26 November 2021  
Stephen O'Donoghue  
Director Resource Assessments  
Department of Planning Industry and Environment  
12 Darcy St, Locked Bag 5022  
Parramatta NSW 2124

We refer to your requests dated 8, 10, 15 and 18 November 2021 for further information in relation to the Bulli Seam Operations (MP08\_0150) Modification 3 Application.

## Attachment A – Summary of Responses

Figure 2 Location proposed in DPIE request for information (approximate location shown by red circle)

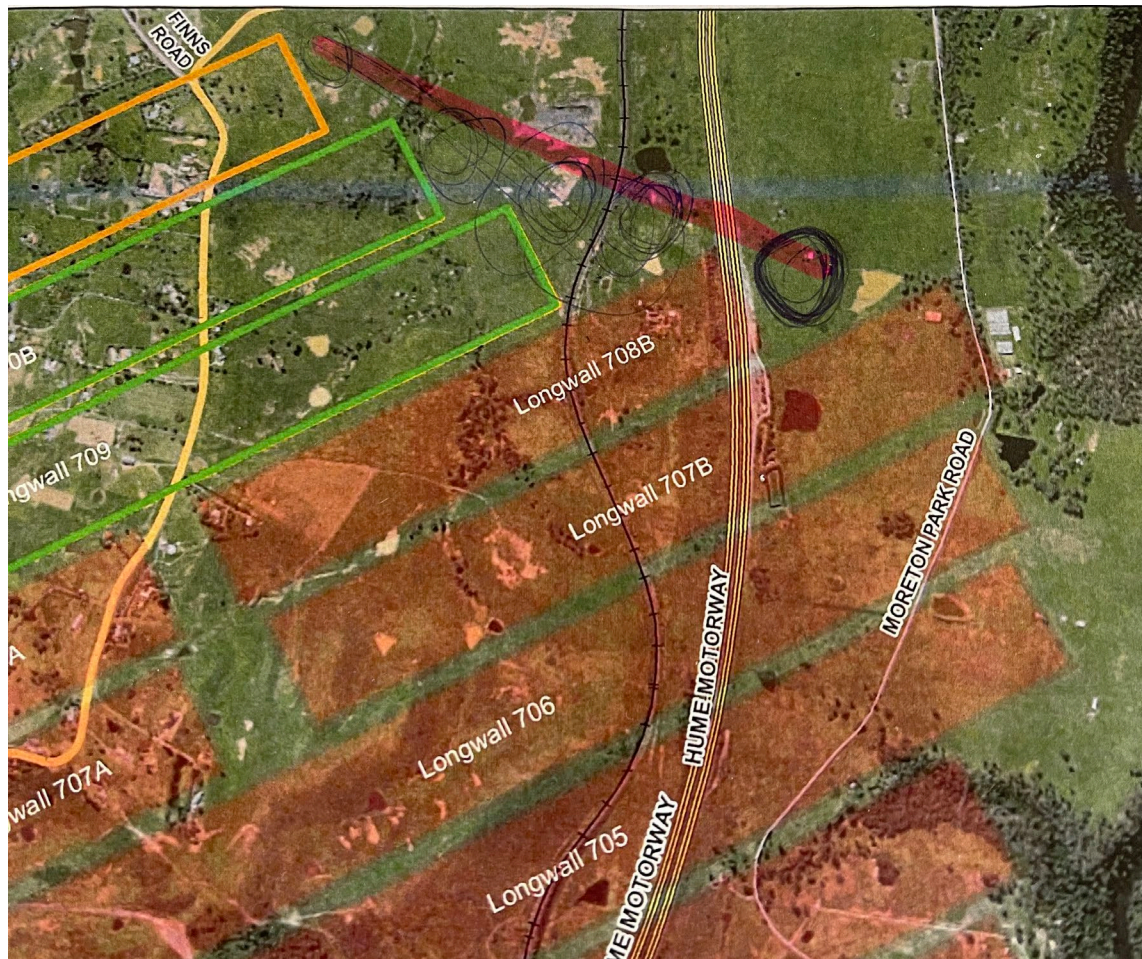
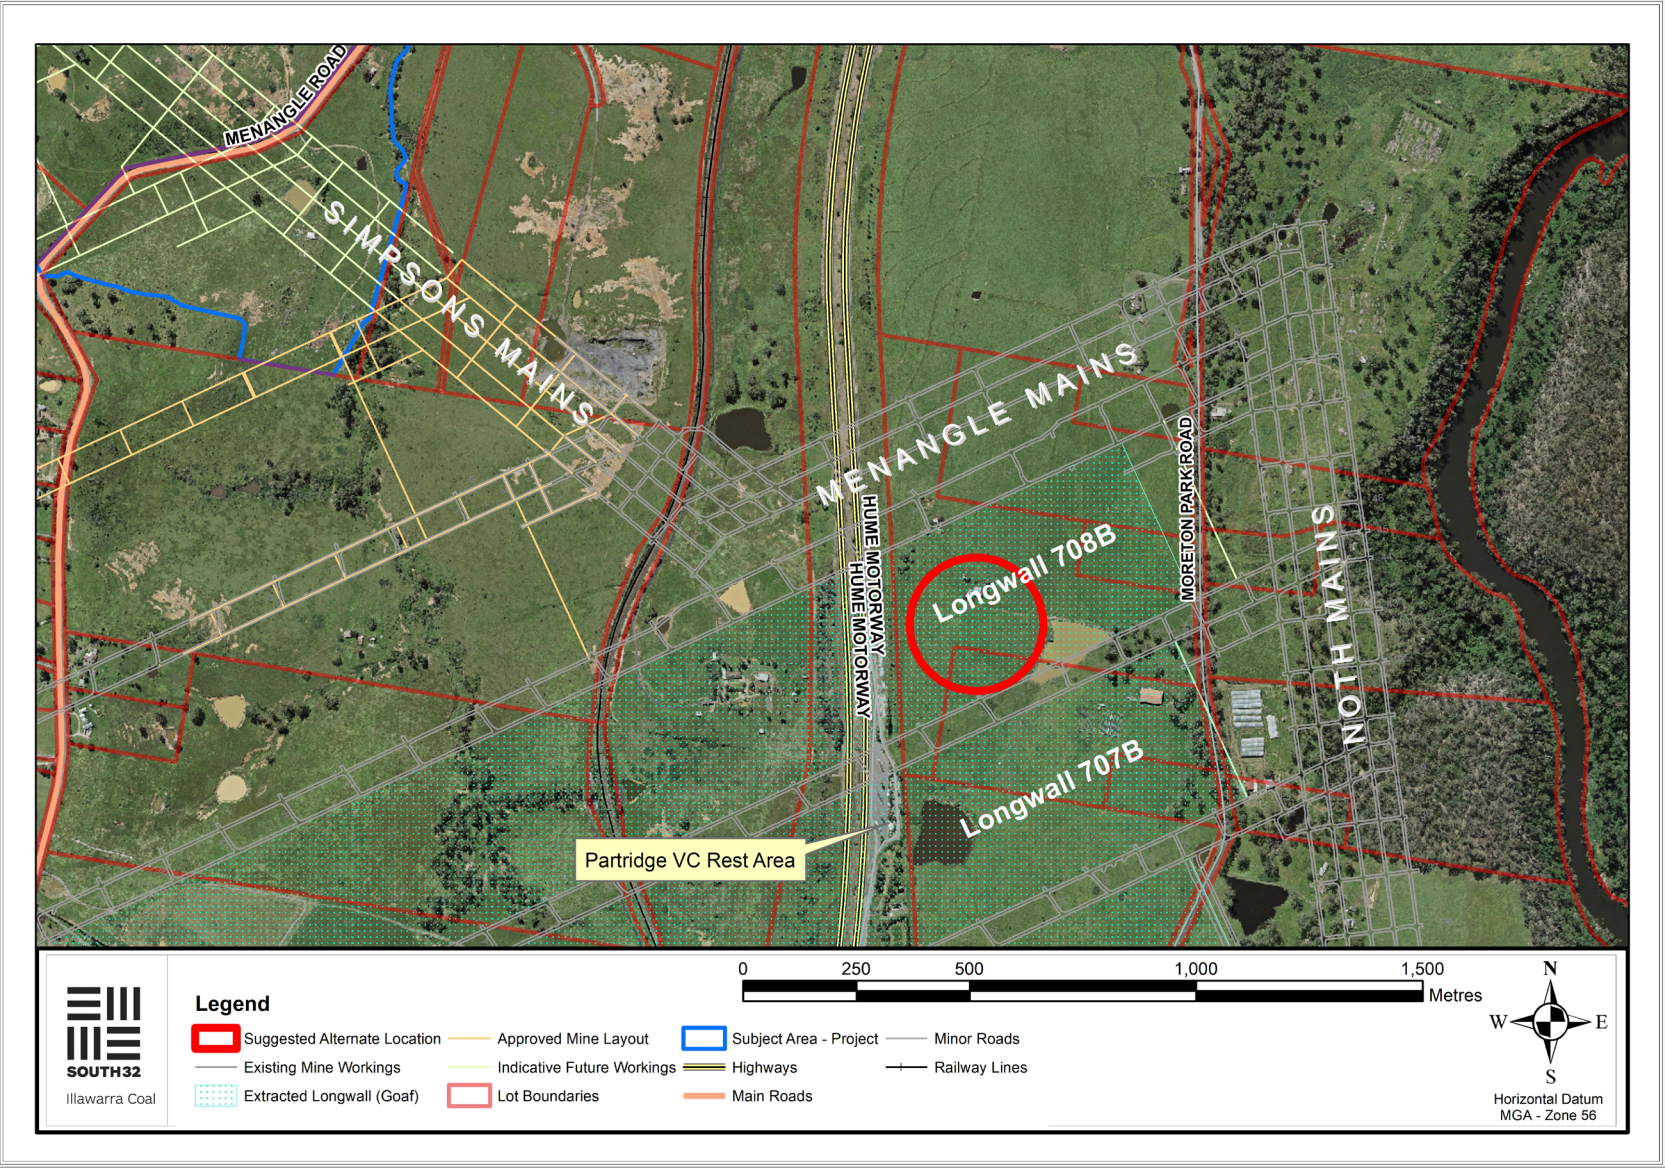
*The Department notes that numerous representations on the modification raised concerns that there was insufficient information provided in the Modification Report or the Submission Report on the consideration of specific alternative locations for the mine ventilation and access site. The Department notes that further information on this issue was provided in email advice from Nicola Curtis on 26 October 2021, however this did not consider specific alternative sites.*

*The Department requests clarification about whether this site was considered in IMCs site options analysis and whether IMC can provide any additional information that would support or discount this specific site as a viable alternative.*

the location to the east of Longwall (LW) 708B extraction (at that time), as marked by the darkest black circle on Figure 1. This map does not represent critical elements required for the shaft planning (namely completed longwall lengths, mains location, indicative future workings, existing property boundaries etc.). The location has been identified on Figure 2, in relation to the underground mining workings and key surface features.

In relation to the proposed benefits of this location, it is noted that this alternate location is over LW707B, rather than directly above Simpsons Mains. The alternate location also overlaps multiple Lots and is within proximity to potential receivers on the various Lots surrounding the location, including R13 which is located immediately to the west.

**Figure 1: Noise Monitoring Locations and Sensitive Receivers**

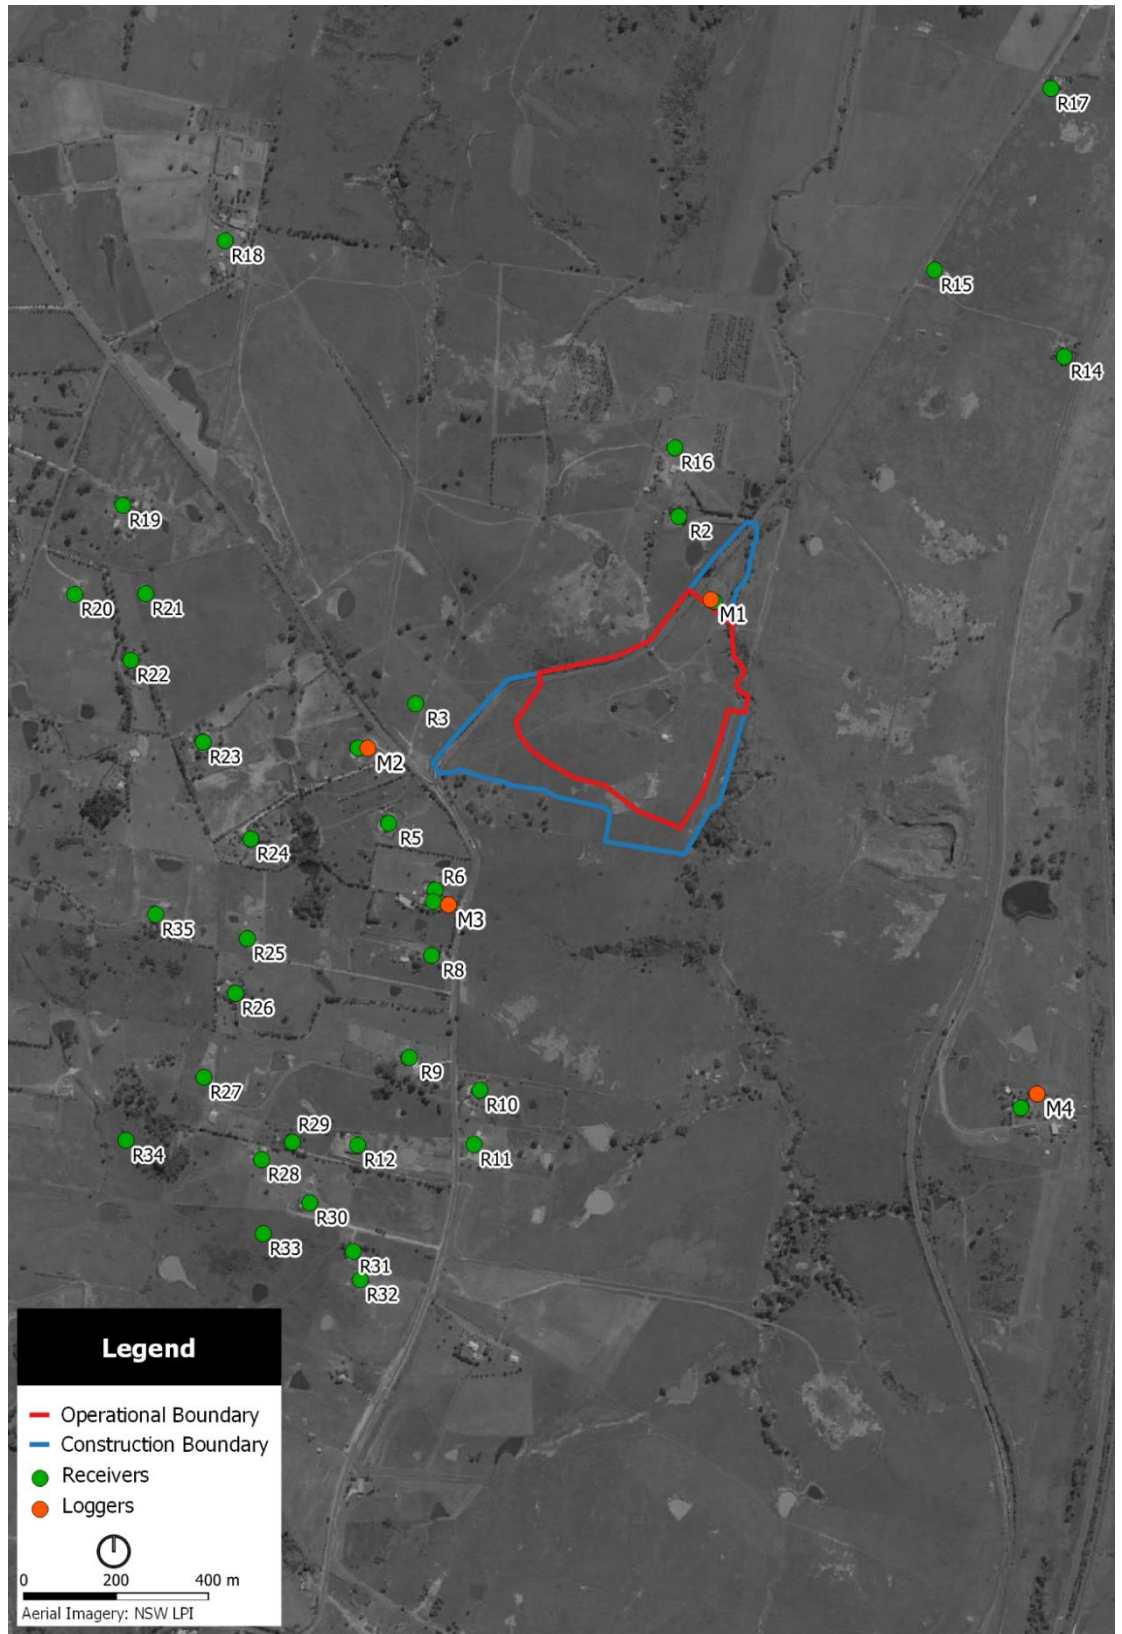
The RFI from the DPIE states the following:

In response to the DPIE's concern that monitoring location M1 may not be suitable due to receivers R2 and R3 being set further back from Menangle Road than location M1, we note that Menangle Road carries low volumes of intermittent traffic, where there are frequent periods of no traffic along this roadway. The  $L_{A90}$  descriptor (which is used to calculate the RBL) quantifies the noise level that is exceeded for 90% of the measurement period and, given the intermittent traffic flow along Menangle Road, the  $L_{A90}$  would be representative of the noise level during the lulls between individual car pass-bys. Considering this, it can be concluded that the measured  $L_{A90}$  will not vary appreciably with distance from Menangle Road and so the  $L_{A90}$  measured at monitoring location M1 will be representative of the background noise levels at receivers R2 and R3.

We agree with the DPIE's comment that the measured  $L_{A90}$  at monitoring location M4 could be influenced by traffic noise from the Hume Motorway as traffic flow along the Motorway will be more continuous in nature. However, this monitoring location was selected to capture the representative noise environment of the residential receivers near the Hume Motorway, such as R13, R14, R15 and R17, and not for residential receivers closer to the site such as R2 and R3. Further, as inferred from the discussion below and as per Table 2, the measured noise levels at location M4 were not used to establish the RBLs at any of the identified receivers.

### Concept Site Design - Indicative Dimensions Appin Mine Ventilation and Access Project

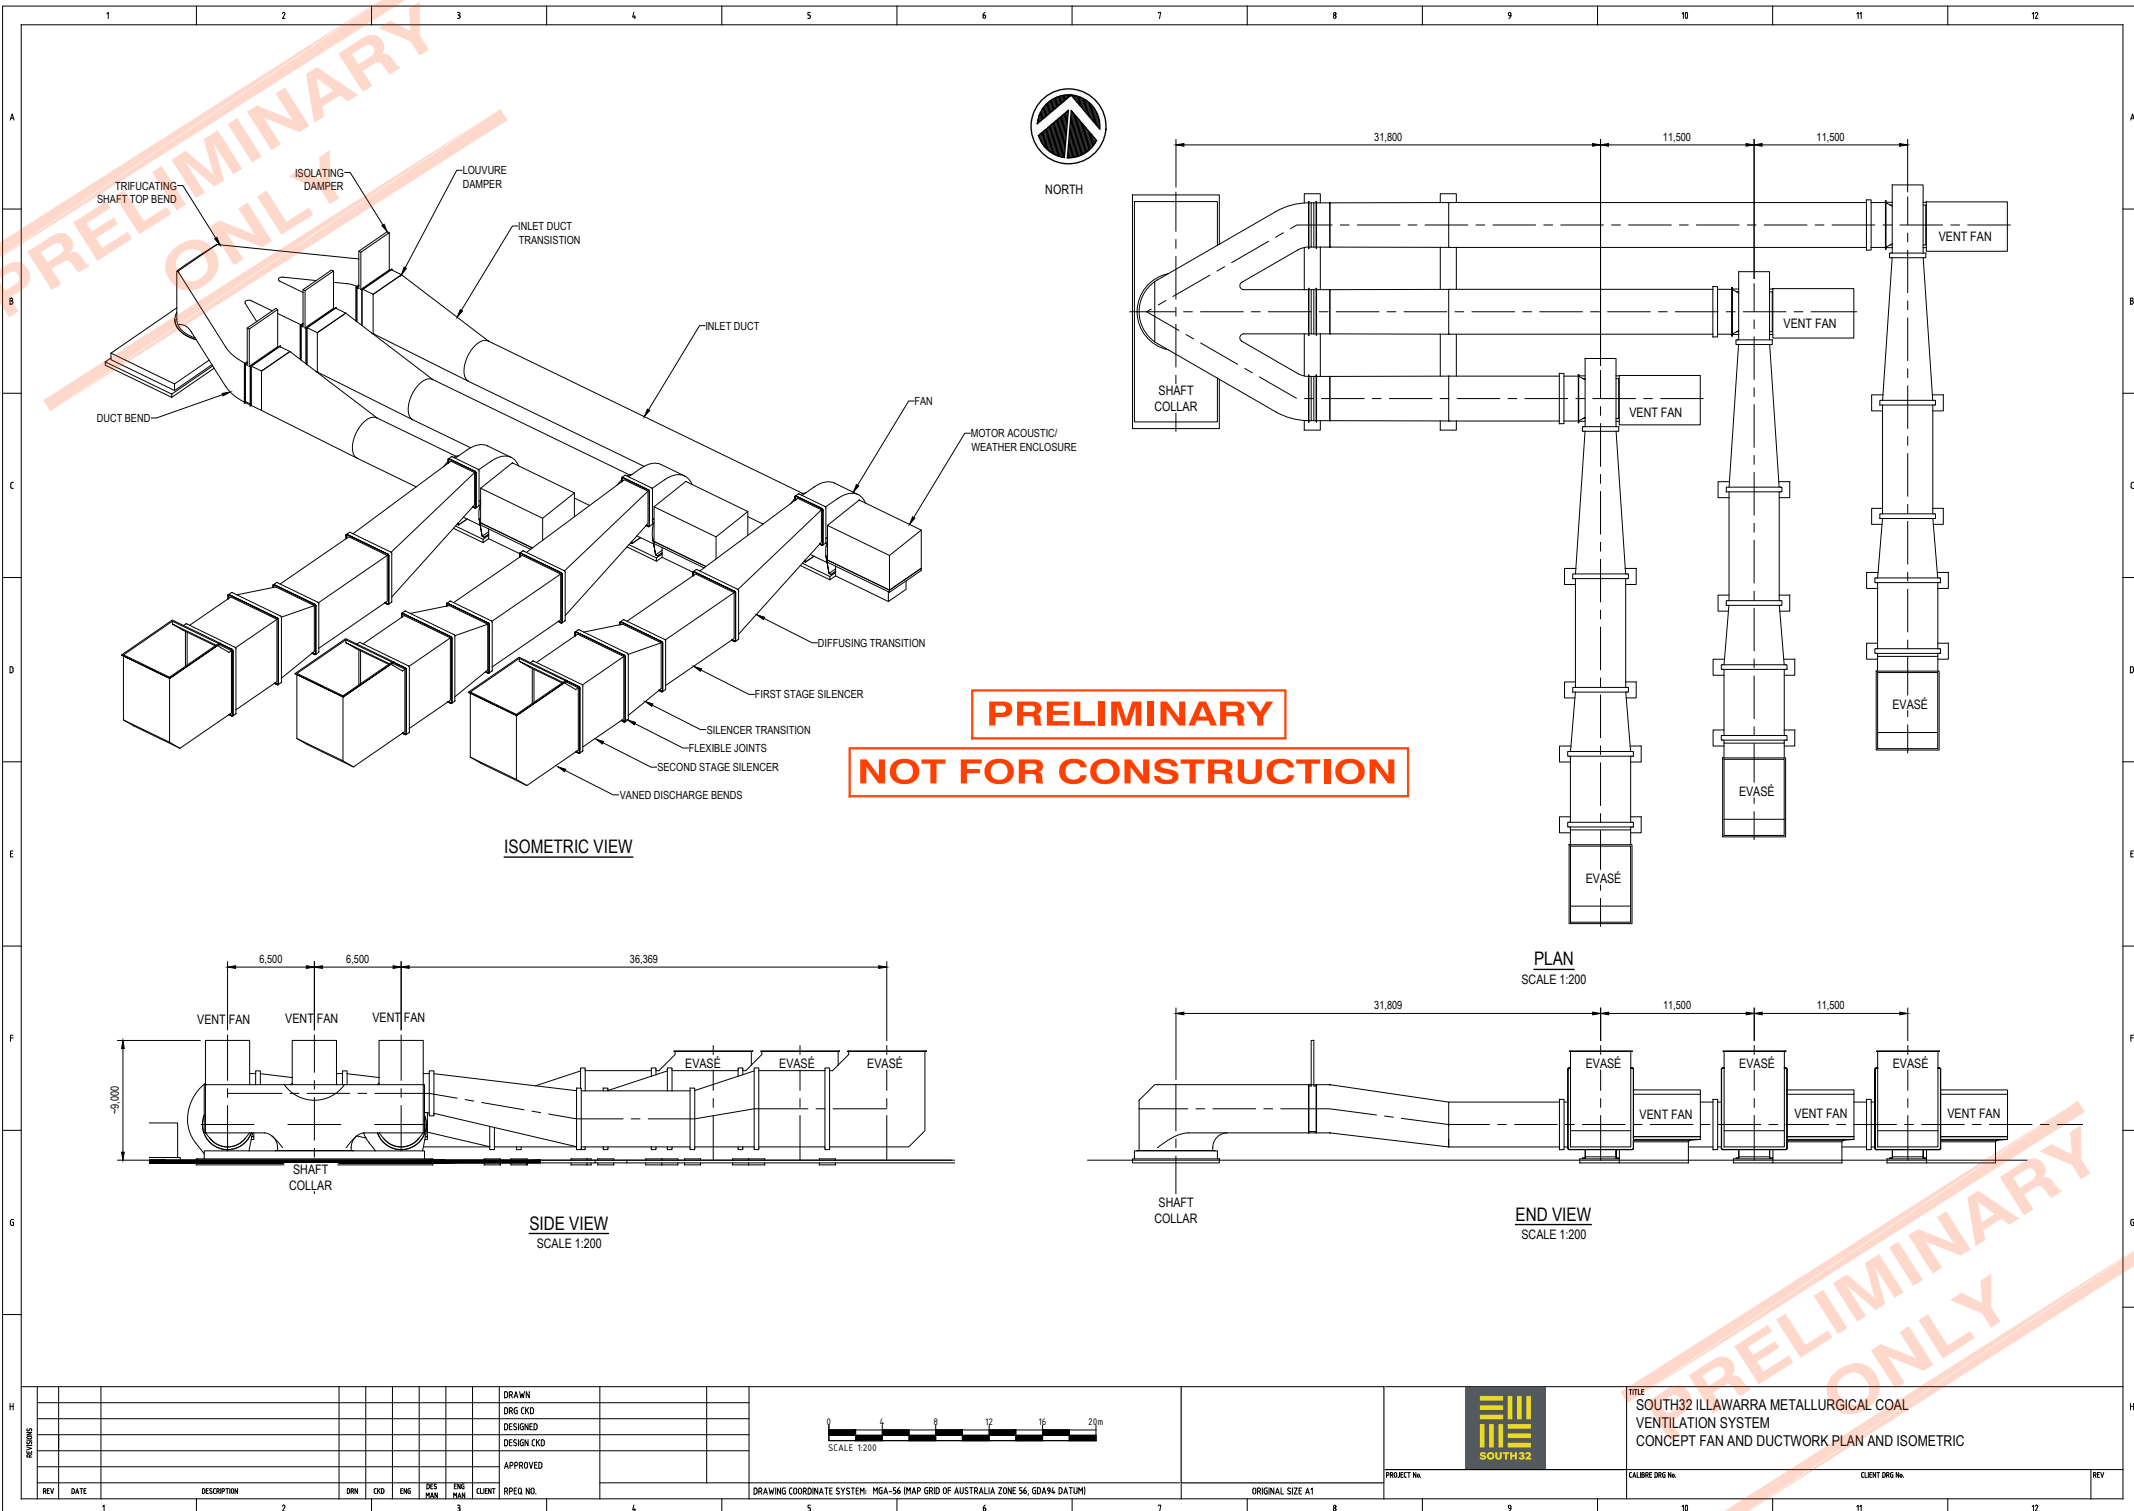
*The Modification Report does not include schematic diagrams of key surface infrastructure and buildings showing dimensions, making it difficult for community members to understand the dimensions (height and width) of the surface infrastructure and buildings in the landscape. The Department notes that schematics of VS7 shown in Figures 3-14, 3-15 and artist impressions in Figure 3-16 and 3-18 do not include dimensions.*

As per the request, concept schematic diagrams of key infrastructure, as well as a plan showing indicative footprints and heights of key infrastructure is provided in Attachment F. It is noted that the designs and related dimensions are based on the concept designs, which are being adjusted and optimised during the current detailed design process.

Concept dimensions of key infrastructure including the winder tower, downcast evase area, ventilation fans, and storage area are also provided in the description of each facility in the Modification Report in Section 3.7.4.1, Section 3.7.4.2, Section 3.7.4.3 and Section 3.7.5.
